GE Energy

MFN 06-528

Subject: Response to Portion of NRC Request for Additional Information Letter No. 60 – Radiation Protection – RAI Numbers 12.2-19, 12.3-10, 12.3-12, 12.4-5, and 12.4-7

**Partial Response to RAI Letter No. 71 Related to
ESBWR Design Certification Application**

Figure 1
UPPER DRYWELL SHIELDING RADIATION DOSE RATES WITL FUEL BUNDLE ON SHIELD/SEAL RING (Gy/h)

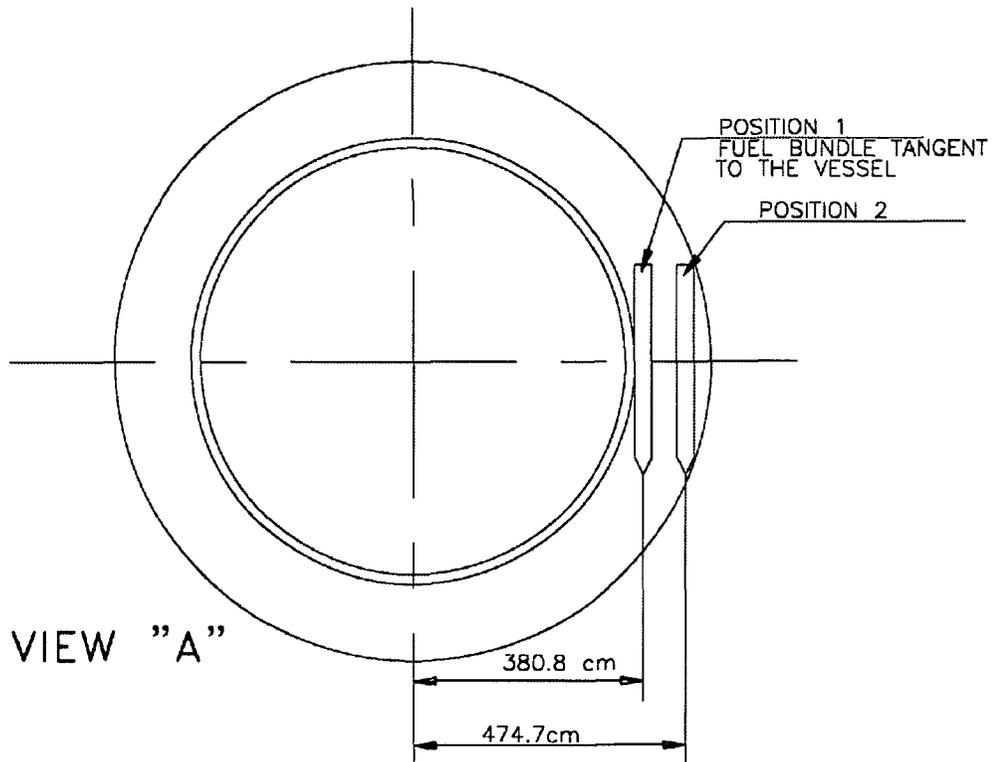
Provide the dose rates in the upper drywell for the worst case drop accident where the fuel rests against the reactor vessel, and where the fuel comes to rest on the vessel flange/refueling pool seal diaphragm.

b. Fuel comes to rest on the vessel flange/refueling pool seal diaphragm

Two different configurations are possible (see Figure 1 entitled “Upper Drywell Shielding Radiation Dose Rates with Fuel Bundle on Shield/Seal Ring”) for this case. When the fuel element drops and comes to rest horizontally and leaning completely on the shielding ring, two positions have been studied:

1. The fuel element is located tangentially to the reactor vessel (position 1); or
2. The fuel element is as close as possible to the cylindrical wall of the cavity (position 2)

The most conservative case is in position 2, as close as possible to the cylindrical wall of the cavity, because the solid radiation penetration angle and its projection on the worker standing on the platform at Elev. +21000 is larger. The shield/seal ring, steel with a thickness of 15 cm, has been considered the largest protection element in this case. In accordance with these conservative assumptions, the dose rate on the platform at Elev. 22800 is 4.7 Sv/h, as indicated on Figure 1.

**Fig. 2 RPV ISI PLATFORMS ACCESS ROUTES
DEVELOPED VIEW BY OUTSIDE**

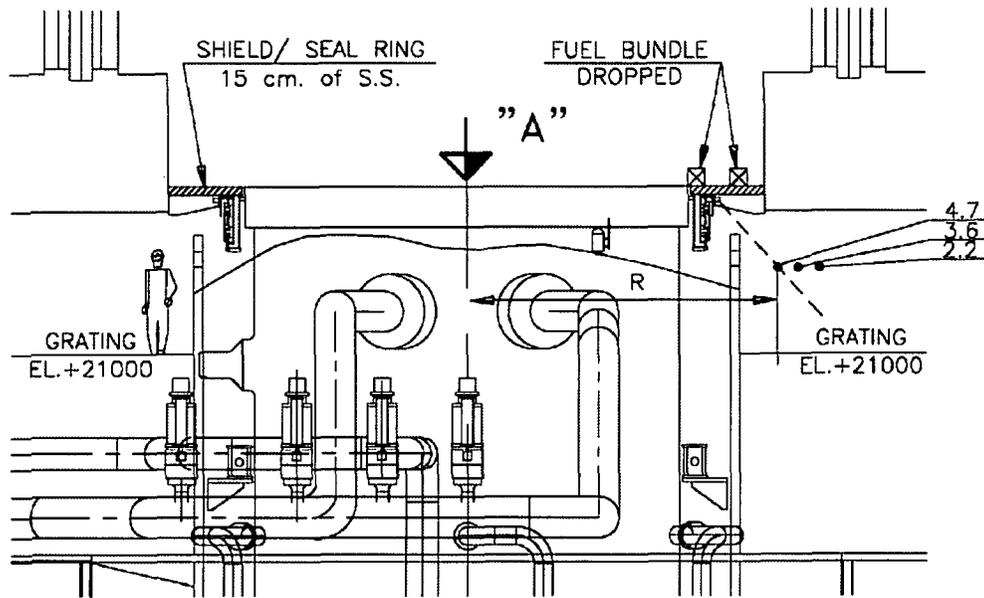
Describe maintenance activities anticipated in the upper drywell (from elevation 9060mm and up) and personnel egress routes during a fuel drop event.

Platforms are located between the Shield Wall and the Vent Wall, and between the RPV and the Shield Wall, in the Reactor Building to facilitate the in-service inspection and maintenance activities during refueling operations and shutdown conditions.

The attached Figure 2 entitled “RPV ISI Platforms Access Routes Development View by Outside” shows the personnel egress routes.
